**UN-COMMANDED TCC APPLY ON THE 1-2 SHIFT
CAUSING PERCEPTION OF HESITATION AND/OR
LACK OF POWER DURING SHIFT**

TSB 09-20-14

This article supersedes TSB **6-22-7** to update the Issue Statement, vehicle model years and model line covered.

Figure 1 - Article 09-20-14

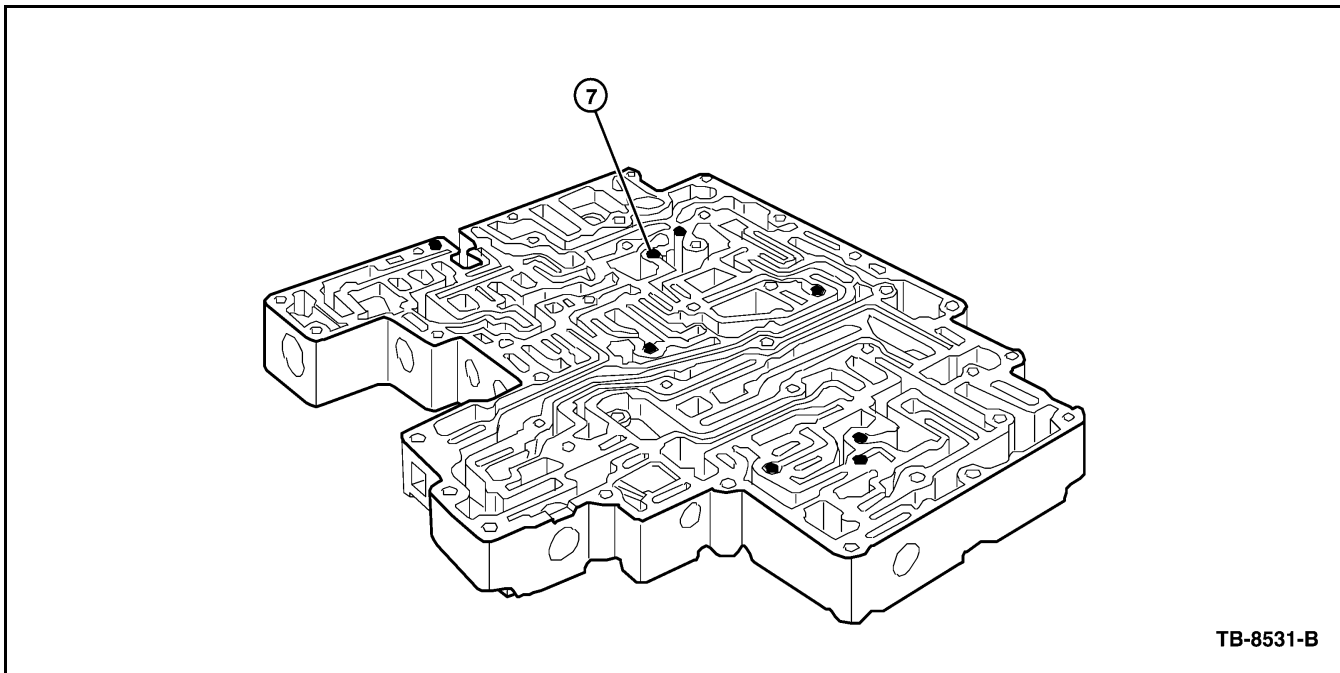
Some 2005-2010 vehicles equipped with a 4R70/75E-W transmission may experience an un-commanded torque converter clutch (TCC) apply or TCC partial apply immediately after the 1-2 shift. This may result in the perception that the vehicle lacks power or that the transmission is up-shifting too early. Additional symptoms of uncommanded TCC apply when coming to a stop (before the 2-1 downshift is commanded), are engine stalling or lugging when engaging manual 2nd while at a stop and code P1742 may be present in continuous memory. However, the vehicle should operate normally in park, reverse, neutral and manual 1st gear.

1. Monitor (TCC %) solenoid command state - duty cycle and (TC SLIP ACT) torque converter clutch slippage - RPM, while in 2nd, 3rd or 4th gear with a TCC % reading 0.
 - a. If TCC % = 0 and TC SLIP ACT = less than 20 RPM then inspect the number 7 check ball in the main control valve body for damage. Replace as required following the appropriate Workshop Manual (WSM) under Disassembly and Assembly of Subassemblies - Main Control Valve Body. (Figure 1)

Follow the Service Procedure for verification and repair.
